**Re: Former Pechiney Cast Plate Facility (3200 Fruitland Avenue)**

As a follow-up to the December 29, 2010 submittal, please find attached the preliminary site-specific grading plan (Figure G-9) and site figures depicting the areas where polychlorinated biphenyls will remain in soil after the implementation of the site-specific Remedial Action Plan (Figures G-9A and G-9B) as outlined in our response to Condition C.3.c. of the July 2, 2010<sup>1</sup> conditional approval letter.

**BELOW GRADE DEMOLITION & SOIL EXCAVATION**  
PECHINEY CAST PLATE, INC., FACILITY  
3200 FRUITLAND, VERNON, CALIFORNIA

**EXTENT OF SOIL CONTAINING PCBs**  
**GREATER THAN 1 MG/KG**

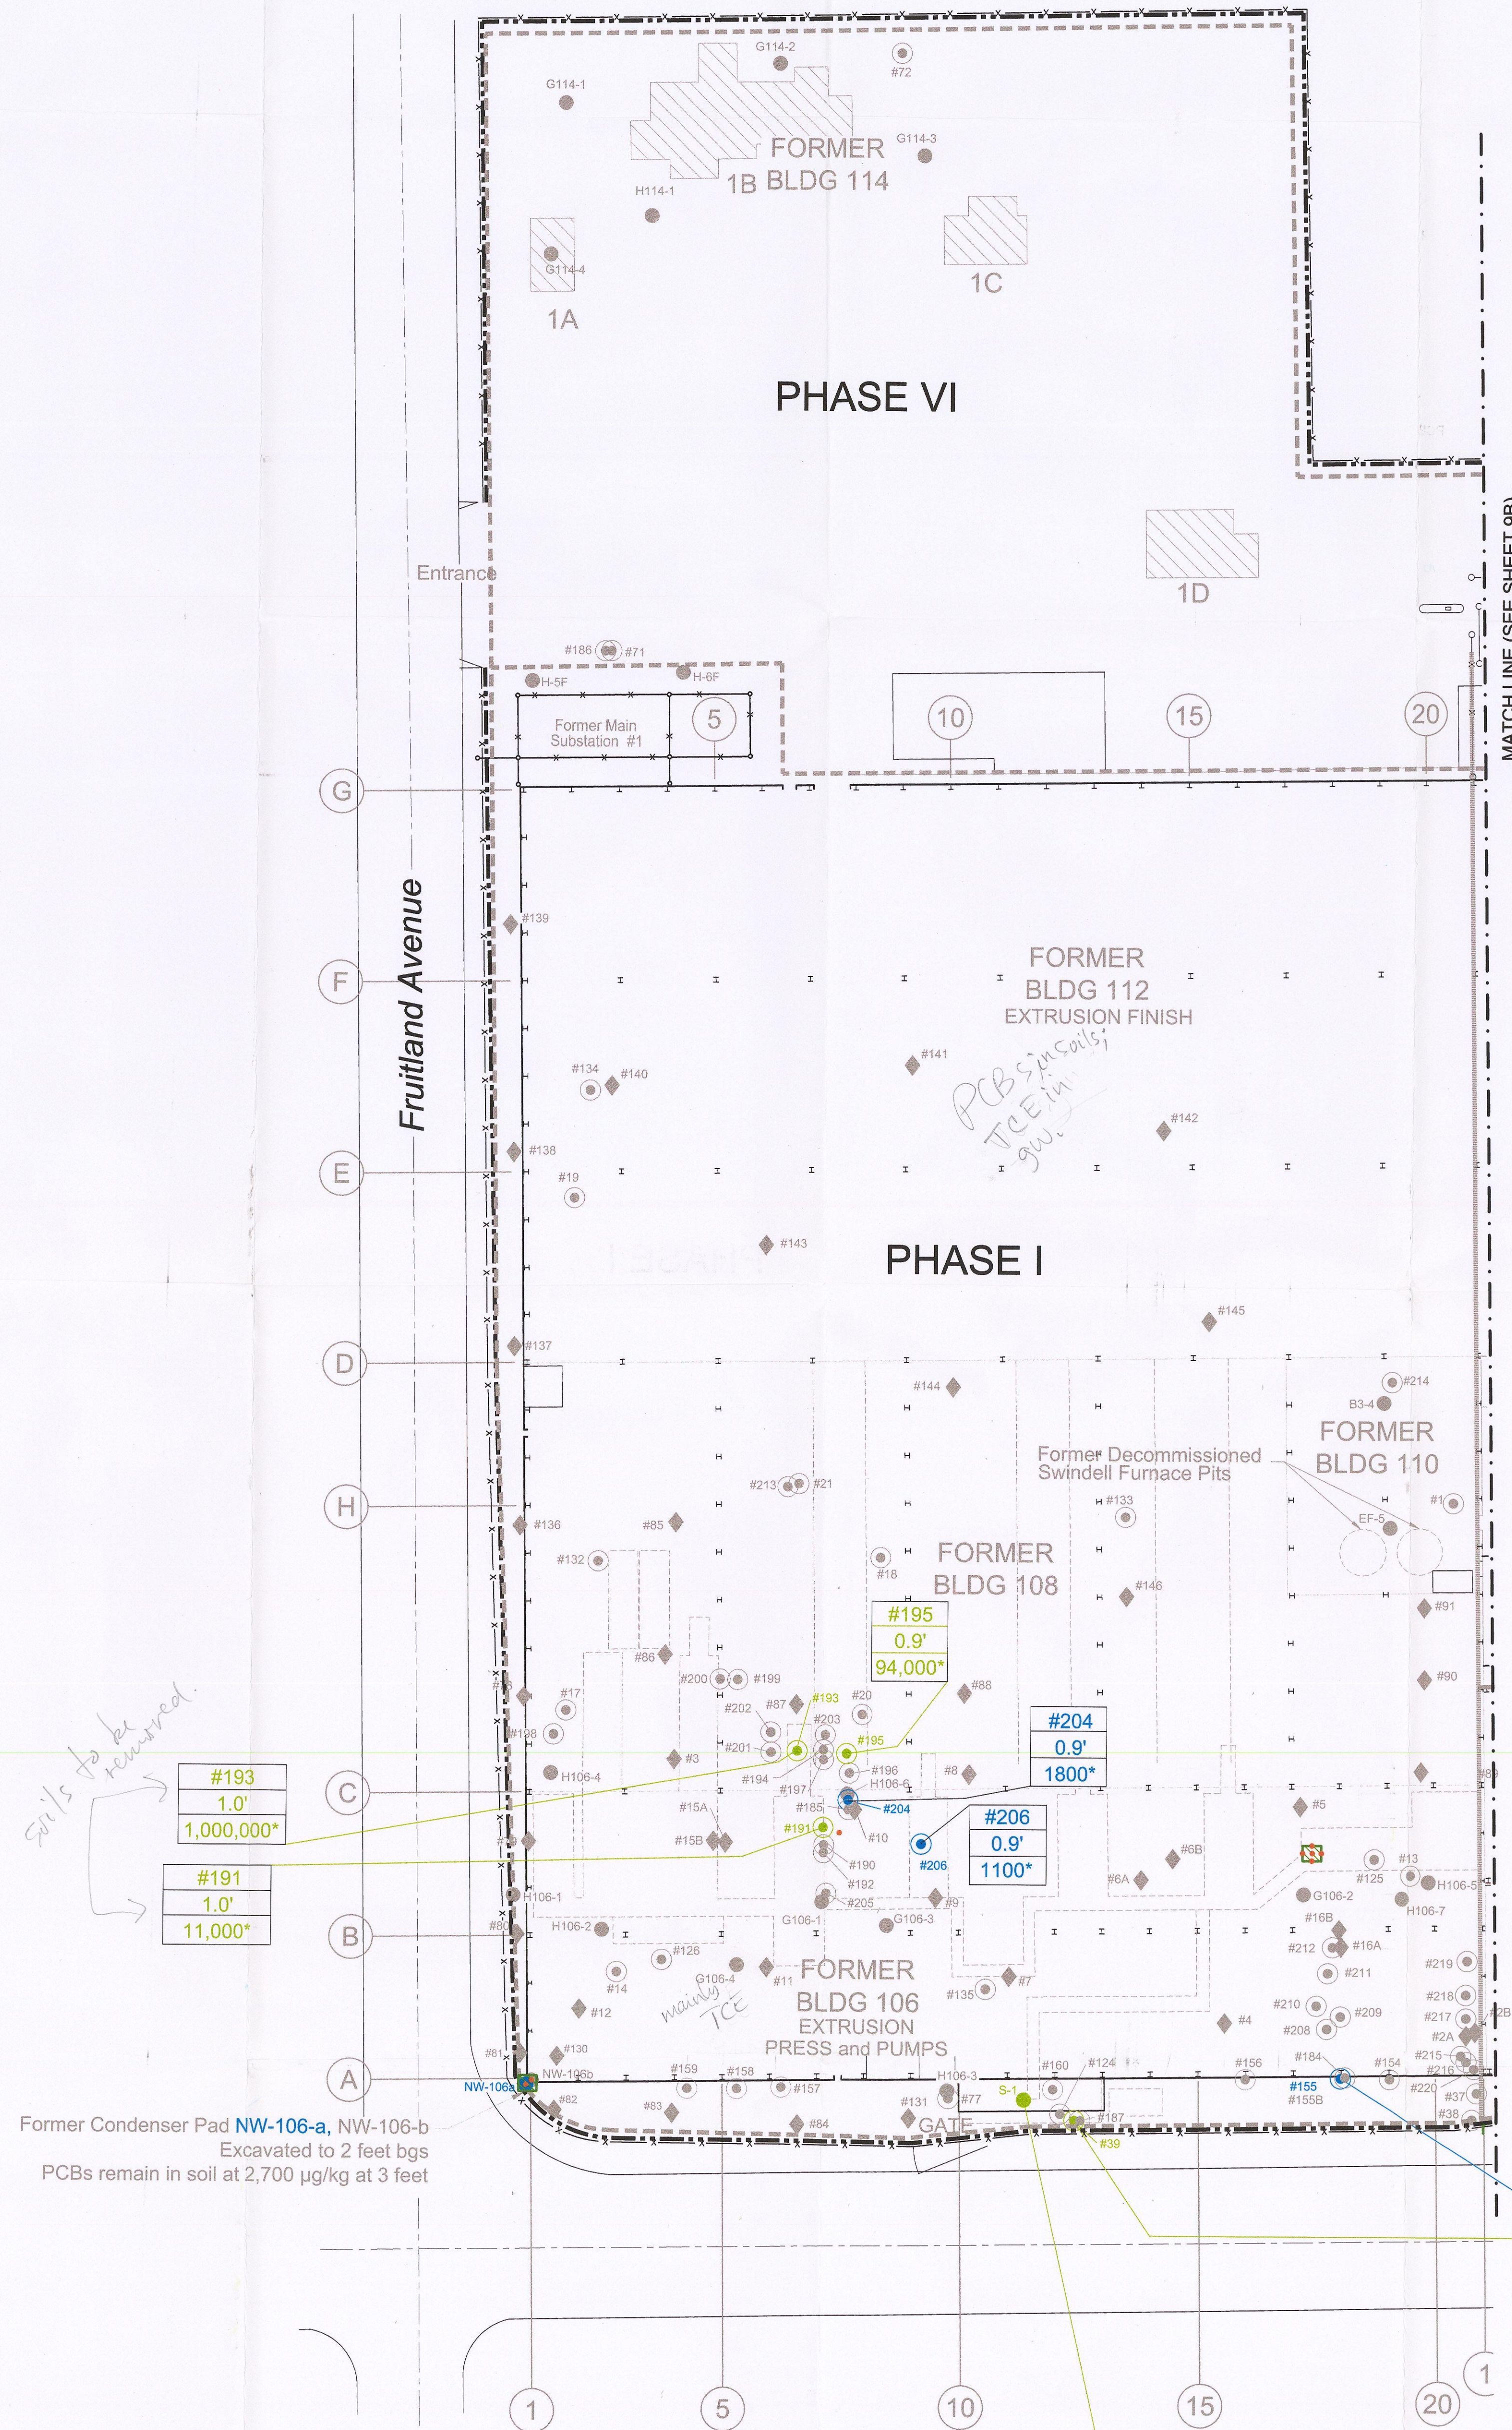
Shows all data where PCBs > 1 and less than proposed cleanup level (2.5 mg/kg) and Green data = soil to be removed.

0-5' = 3.5 mg/kg re proposed

5'-15' = 23 mg/kg re proposed

0-23' = 2.5 mg/kg

Soils will be removed if above 2.5 mg/kg
